### Staff Report City of Richmond, Virginia

## **Urban Design Committee**

UDC 2025-20	Conceptual Review	Meeting Date: 7/10/2025
Applicant/Petitioner	Yongping Wang / Department of Public Works	
Project Description	UDC 2025-20 CONCEPT Location, Character, Extent r reconstruction of the bridge over CSX on Arthur Ashe B Norfolk Street and Boulevard West.	
Project Location		
Address: Arthur Ashe Boulevard over CSX		
Property Owner: City Of Richmond Department of Public Works	181	City Garage
High-Level Details:	1806	OCH COLLEGE
A Concept proposal for the replacement of the existing Arthur Ashe Boulevard Bridge over CSX.	1732 A 1732 A 1732 A 1726 A 1724 A 1725	CIN Carage
Staff Recommendation	Staff recommends approval with conditions.	
Staff Contact	Ray Roakes, Raymond.Roakes@rva.gov	
Public Outreach/ Previous Reviews	No Previous Review	
	Outreach detailed in Applicant Report.	
Conditions for Approval	<ol> <li>Final details on outdoor lighting be sensitive to li compliant.</li> </ol>	ght pollution or dark-skies

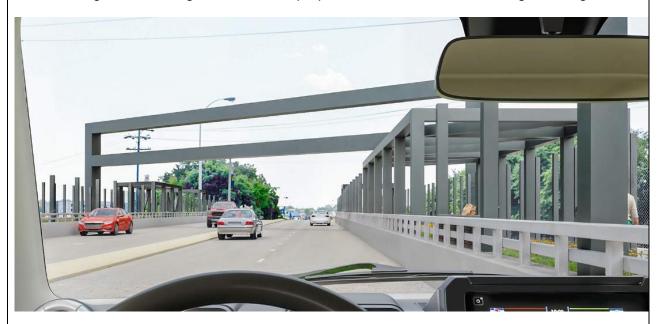
Staff suggests that the stand-alone vertical elements on the sides may make the structure appear unfinished. The use of the same element (dark metal beam roughly the same size) throughout the design may make the structure appear monotonous. Staff suggests that the design needs a greater hierarchy in elements as well as further attention to the stand-alone vertical elements, perhaps something overhead tying everything together. This could be an opportunity to introduce an interesting design element that not only brings the poles together but the entire bridge.

Staff further suggests that the "Landmark" overhead element may not be quite fully formed yet and needs further consideration. The element has the same dimensions as a sign structure on the interstate highway system. With signage installed -unless very stylized- it will appear as such, which would reduce the effectiveness of the "Landmark" character.

- 1. Staff recommends submission of a planting and maintenance plan at Final Review.
- 2. Staff recommends specifications for any built structures, site features, and / or furnishings be included in for Final Review.
- Staff recommends that final outdoor lighting details minimize light pollution or follow darksky compliance.
- 4. Staff recommends the Applicant incorporate public art, where feasible.
